City of Tualatin

ARCHITECTURAL REVIEW FINDINGS AND DECISION

Case #:	AR-15-08
Project:	Hansen's Corner Parking Improvements
Location:	17650 SW 63 rd Ave, Lake Oswego (postal address) (Tax Lot 21E 18BC 01400)
Applicant:	Irina Leschuk, DL Design Group, Inc. (503-644-4628; Project No. MCG010); Dean McGregor, River Preservation LLC

Excerpt of Landscape Plan

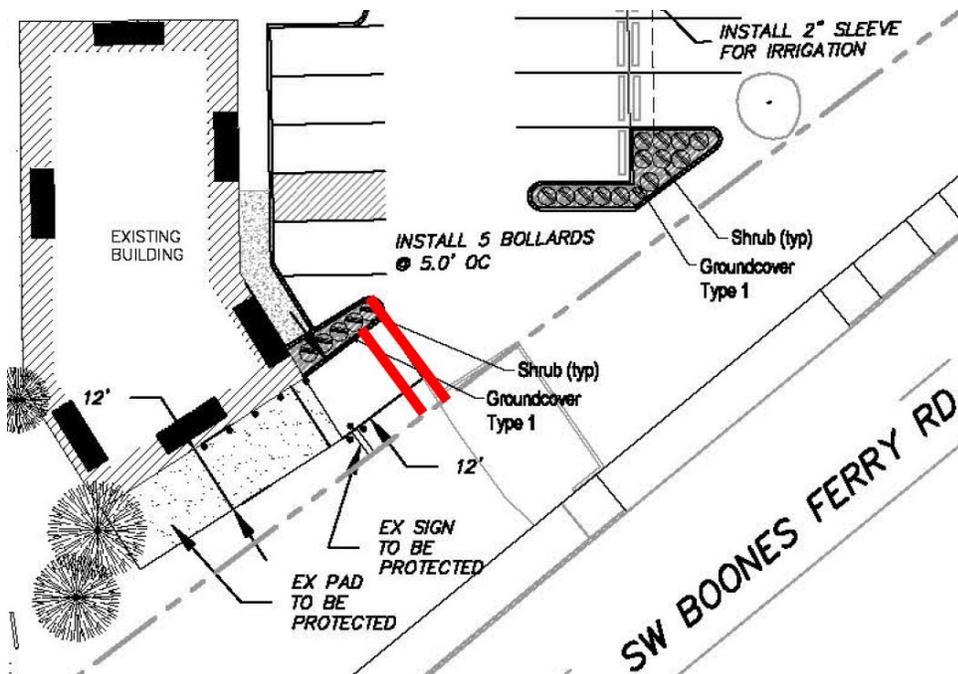
As the landscape plan excerpt below illustrates, the proposed southwesternmost landscaped island as slightly narrower than 5 ft in width, failing to meet the requirement of (2). The plan illustrates a seemingly purposeless triangular area of asphalt to the north between it and a parking stall, providing area for the applicant to widen the island.

- The applicant shall revise the site plans to illustrate the proposed southwesternmost landscaped island with a minimum 5-foot width.

Site Plan Excerpt

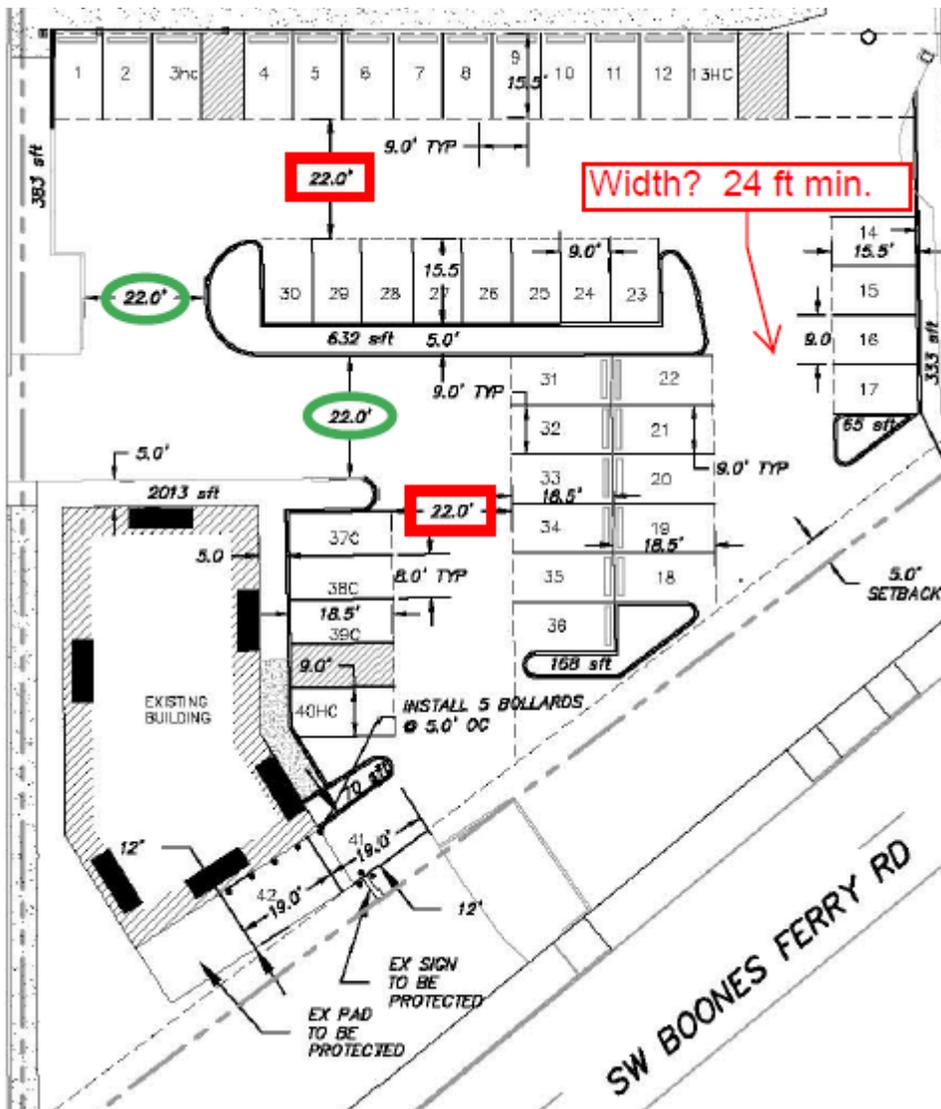
Regarding (11), the parking area reconfiguration proposes 22-ft two-way drive aisles, which meet the requirement for where (11) allows 22 ft, along drive aisles with no parking stalls; however, [Figure 73-1](#) notes through “Dimension Aisle width between stall lines” and “On Diagram D” that parking stalls at 90 degrees to a drive aisle require that aisle to be 24 ft wide, not 22 ft. Therefore, as indicated in red in the site plan excerpt below, three drive aisles need to be widened from 22 to 24 ft:

- The applicant shall revise the site plan to illustrate that on-site drive aisles with parking spaces have minimum widths pursuant to [Figure 73-1](#), "Dimension Aisle width between stall lines", "On Diagram D".

- The applicant shall revise the site plan to illustrate that on-site drive aisles without parking spaces have the required minimum widths.

**SW BOONES FERRY RD
@ SW 63RD AVE
LANDSCAPE PLAN**

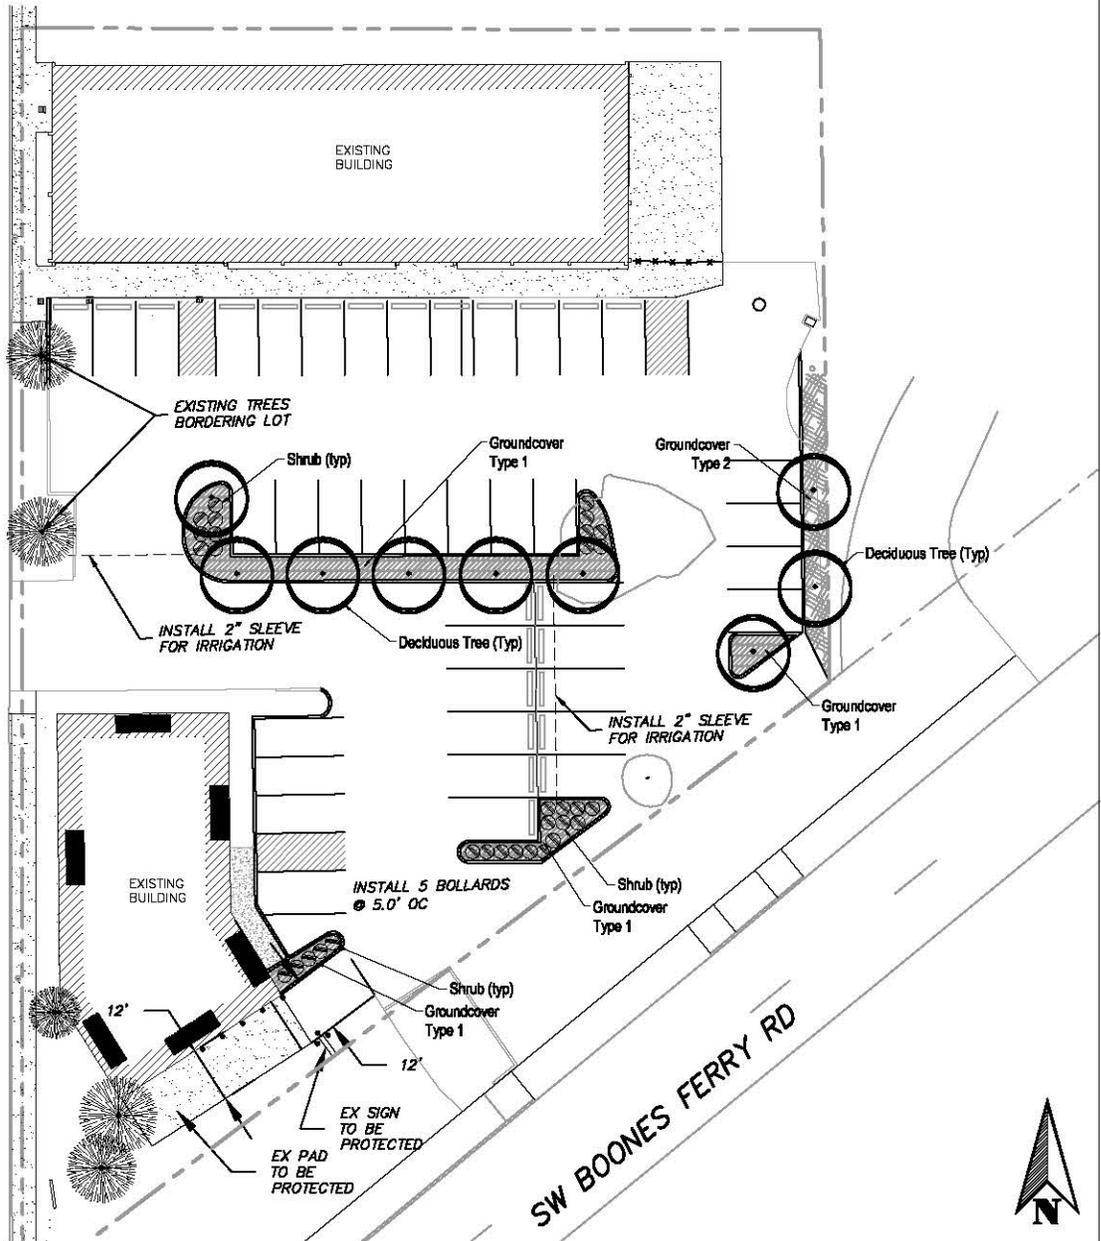
Because the site plans do not indicate the total square footage of landscaping or a percentage of Lot 1400, staff cannot determine compliance and so is applying a condition.

Because the site plans do not note retention or addition of an automatic irrigation system, staff cannot determine compliance and so is applying a condition.

- The applicant shall revise the landscape plan to note the square footage of landscaping on the subject tax lot and its percentage of the lot.

- The applicant shall revise the landscape plan to note an automatic underground or drip irrigation system.
